Delegated Report

Discharge of Conditions

Planning Application No: 20231080

Location: 18 Marks Square Northfleet Gravesend Kent

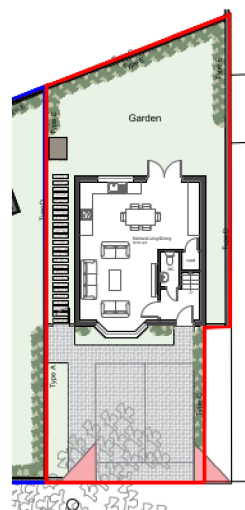
The submitted details of the layout for the site frontage of the new dwelling are not consistent with that which was approved under planning permission 20220175.

At the site visit, it was noted that the 'as built' site frontage, does not accord with either of the above drawings;

Furthermore, there appears to have been alterations to the ground levels at the front of application site, which were not part of the approved development under 20220175;
